Re: Bulk Sample Plan
Response to Comments dated August 13, 2013
Wisconsin Statutes 295.45

DNR COMMENT LETTER DATED
JULY 2, 2013

DNR COMMENT LETTER DATED
AUGUST 13, 2013

BULK SAMPLE PLAN

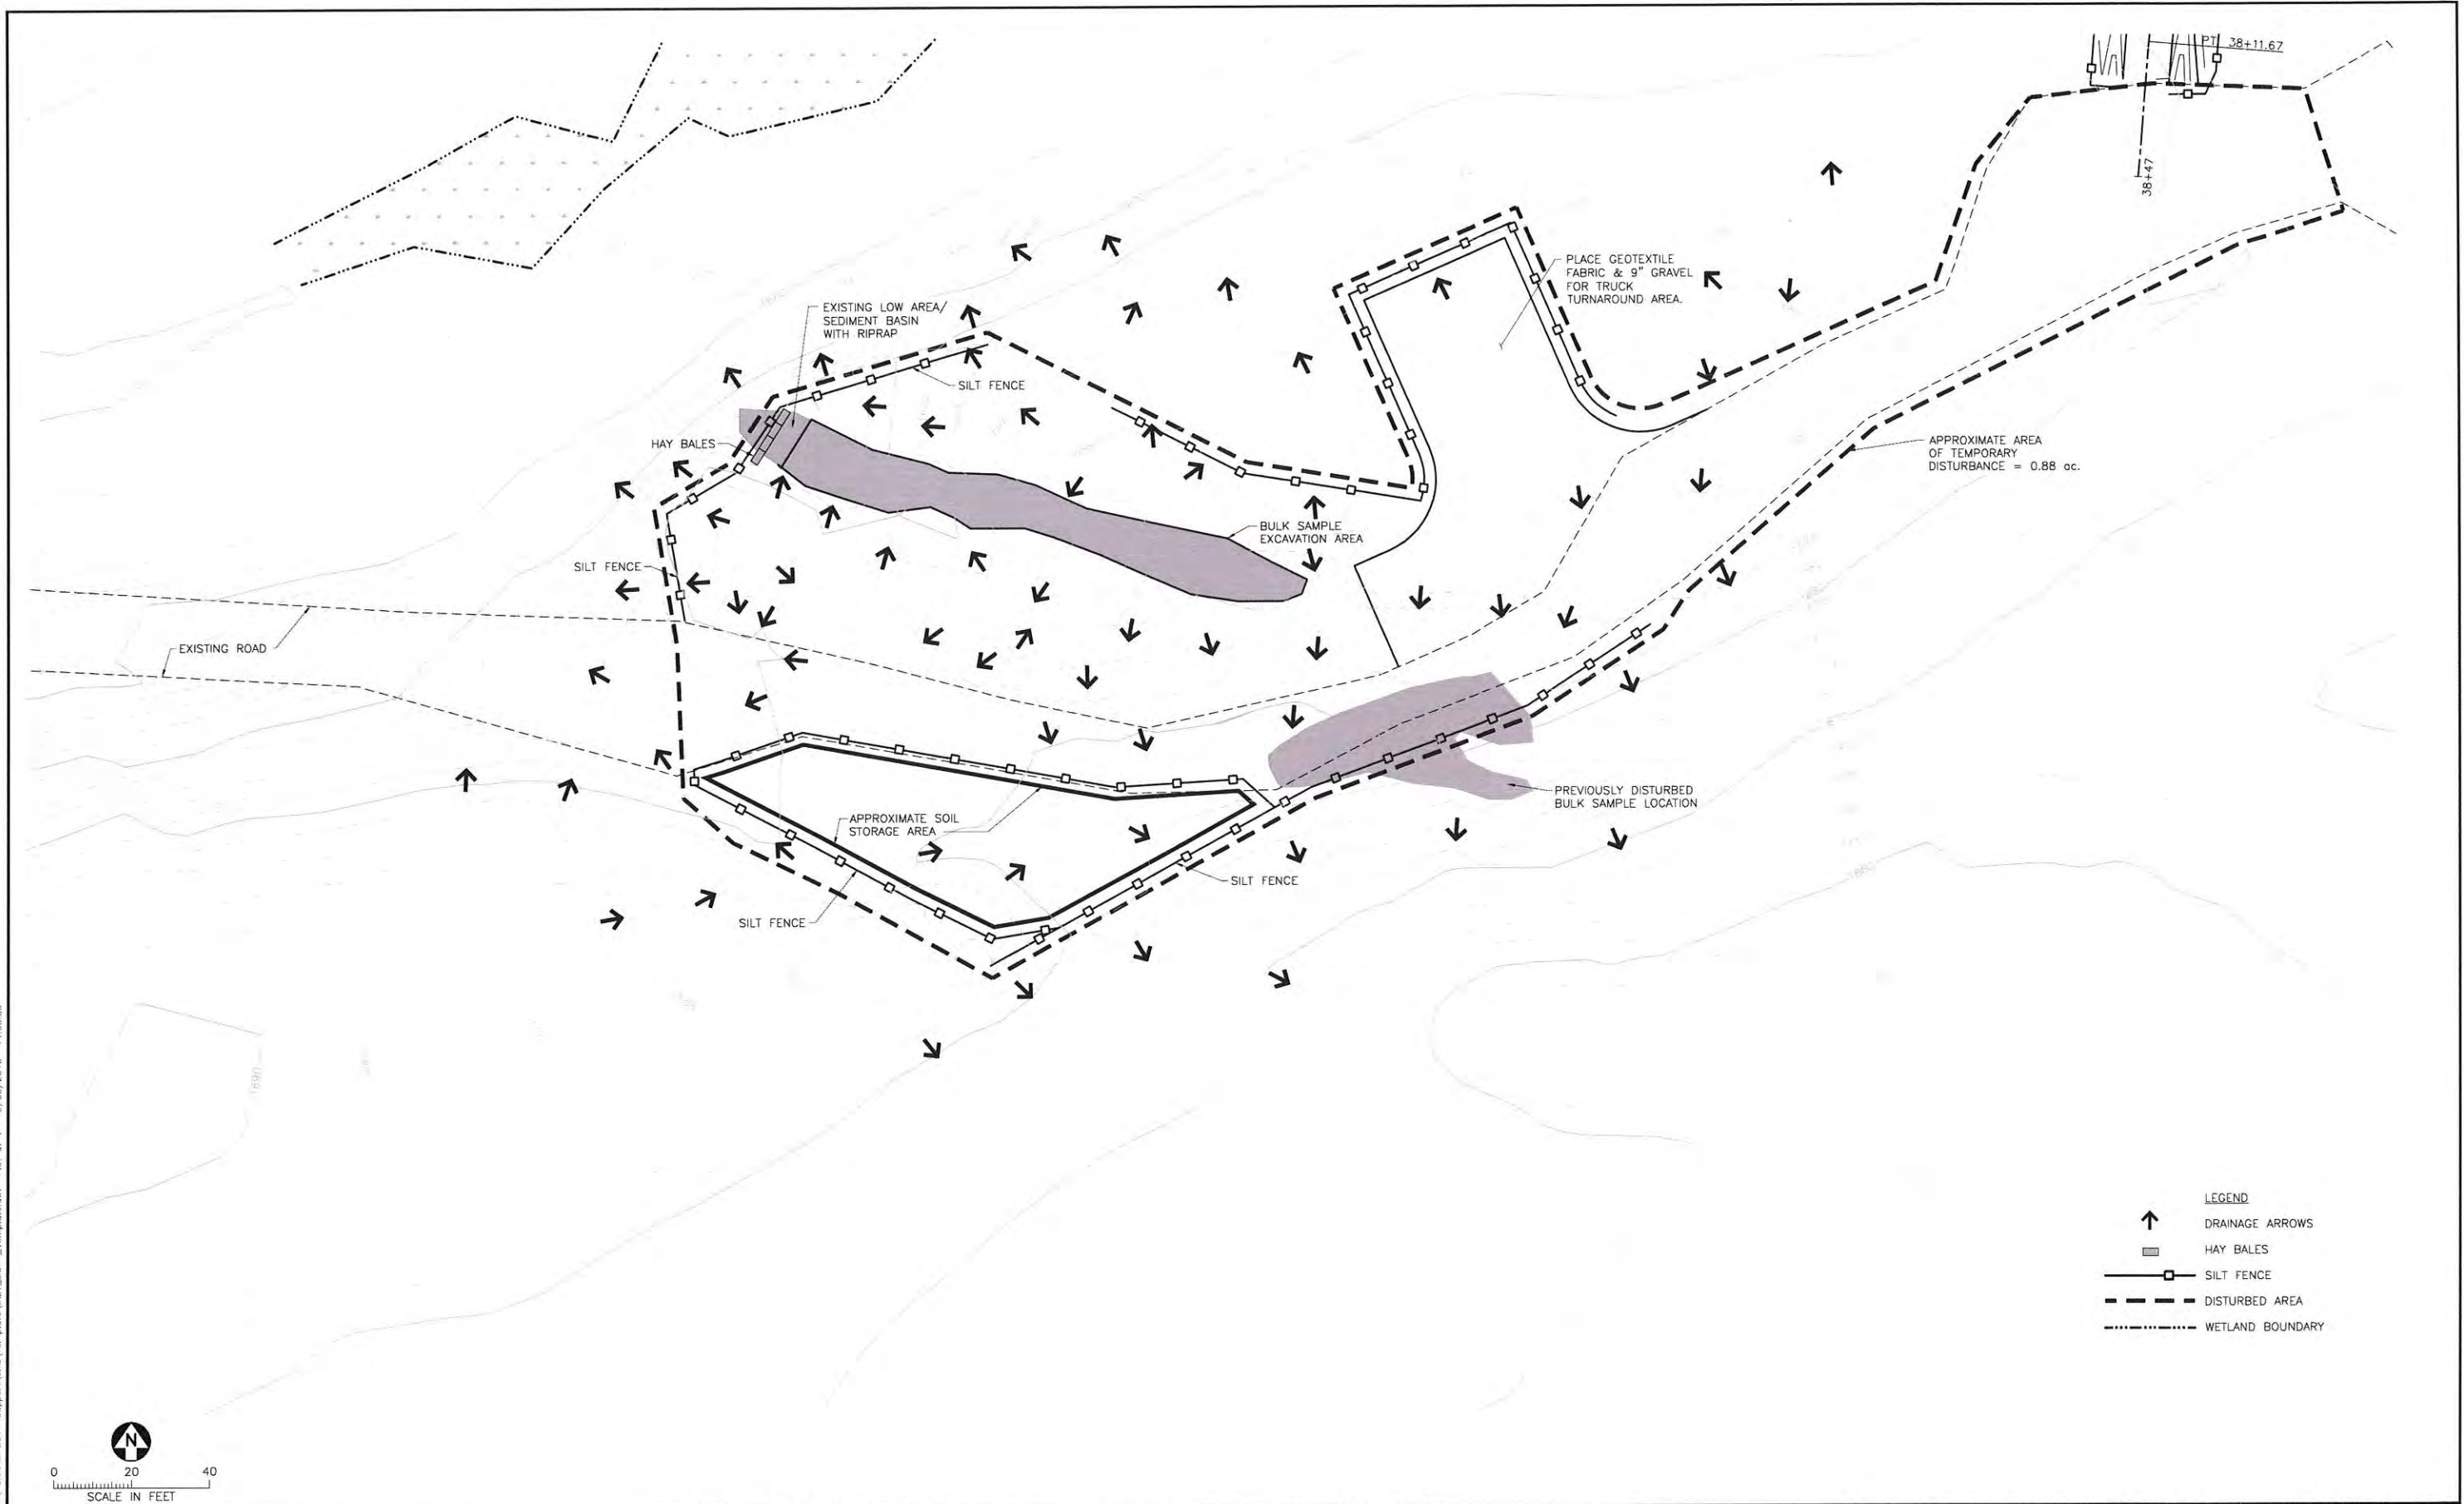
- 1) Bulk Sample Site 1 has been modified to show a truck turning area.
- 2) Bulk Sample Site 2 has been modified to reduce the footprint of the activity.

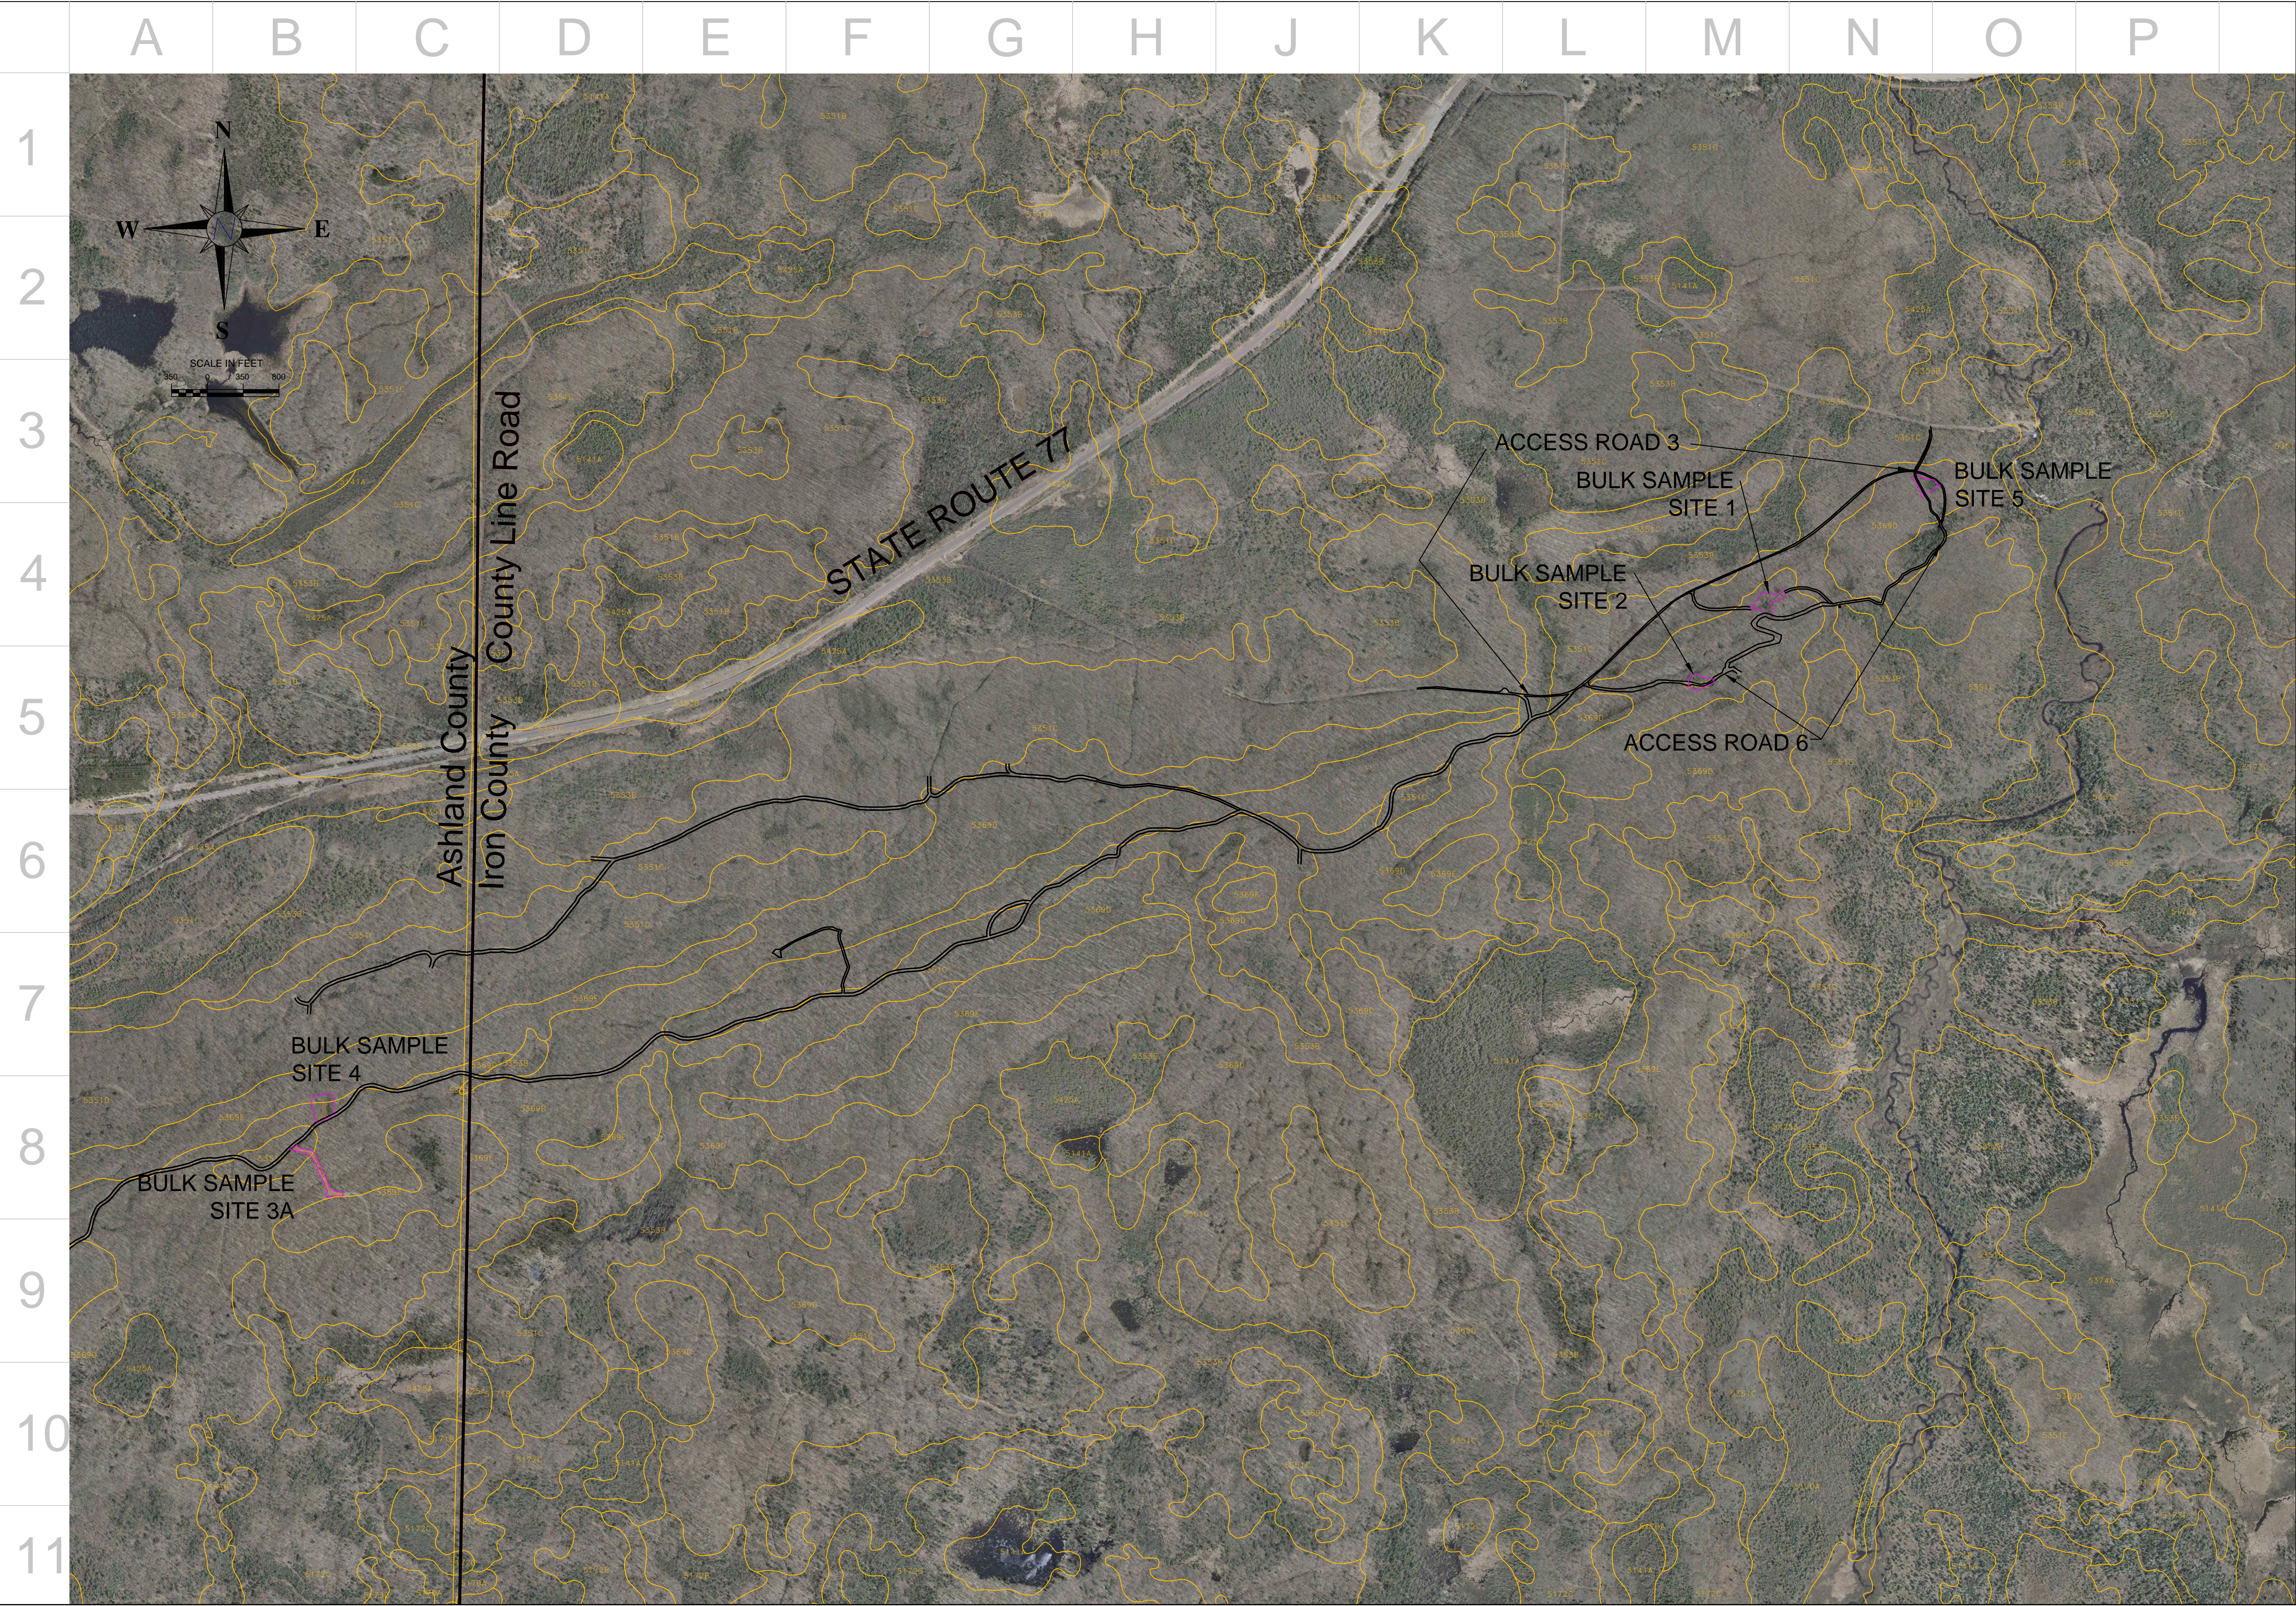
6. Response #8 refers to the wetlands delineation report. Figures 3 and 4 from that report are of poor resolution and are difficult to read. Please submit better quality versions of figures 3 and 4.

- 14) From the DNR August 13, 2013 comment letter Item 5: A sulfide and grunerite screening process has been included within the Bulk Sample Plan.
- 15) From the DNR August 13, 2013 comment letter Item 6: The wetlands delineation report has been modified and revised drawings are provided. Additional offsite delineation was performed.
